Piper Aircraft Corporation

# SERVICE BULLETIN

**No. 203**

SUBJECT: Modification of Cabin Heat Box Plate

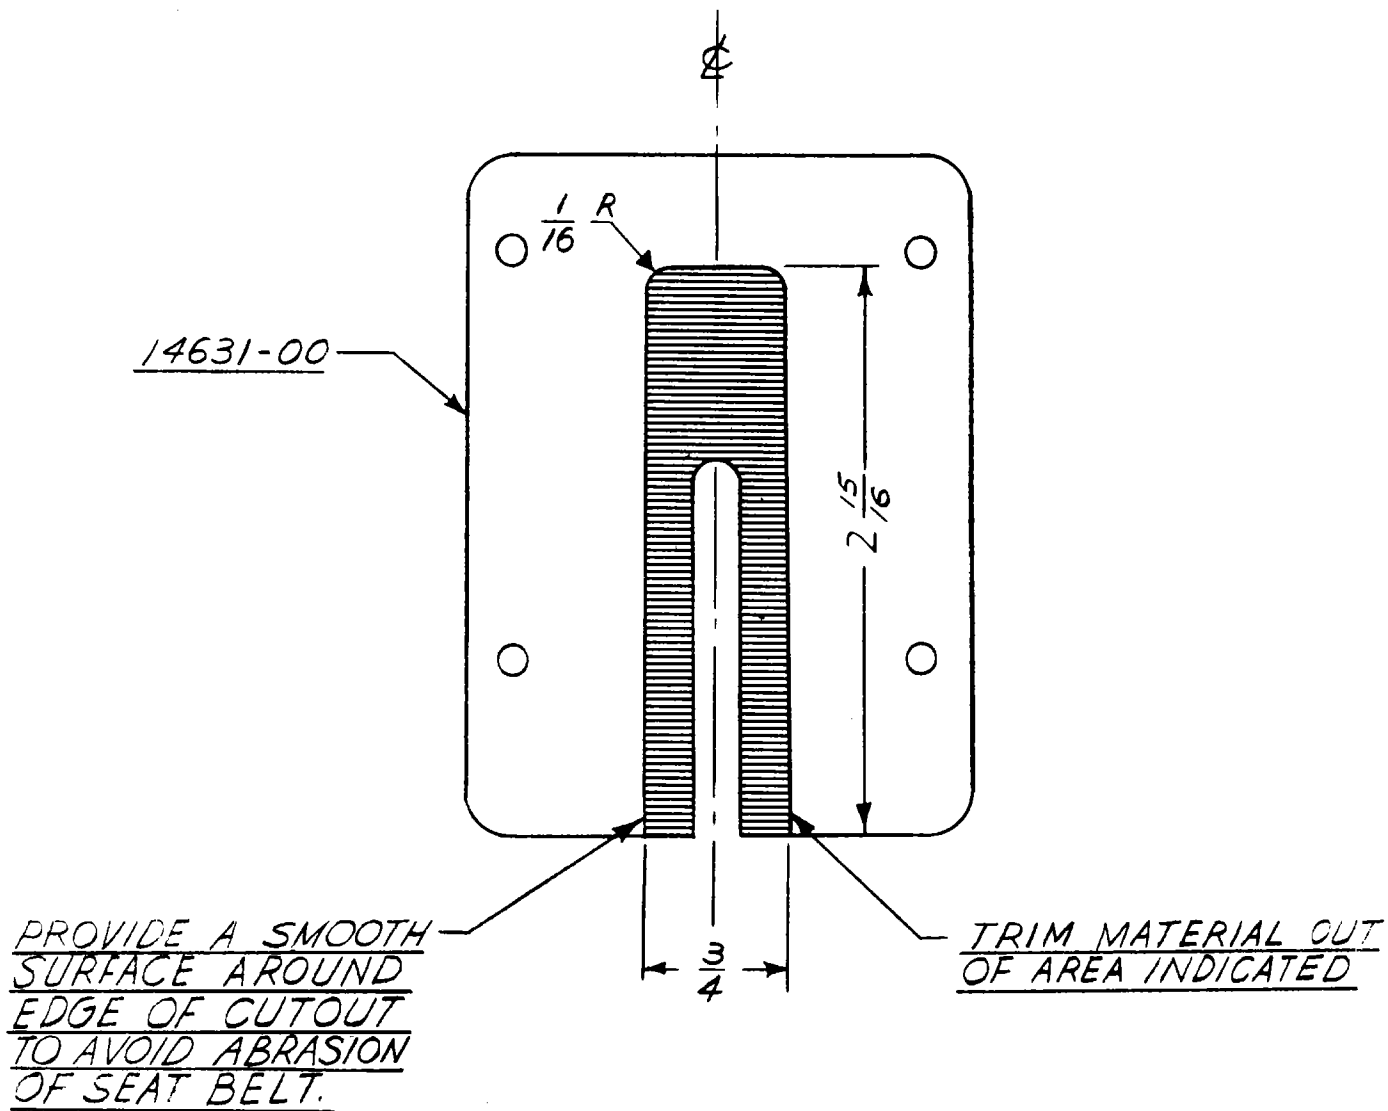
The cabin heat box plate part number 14631, interferes with the movement of the safety belt attaching link. This restriction of movement prevents the safety belt loop from contacting the entire bearing surface of the link when the safety belt is in use.

It is requested that the cabin heat box plate be modified in accordance with the sketch of the reverse side on this bulletin.
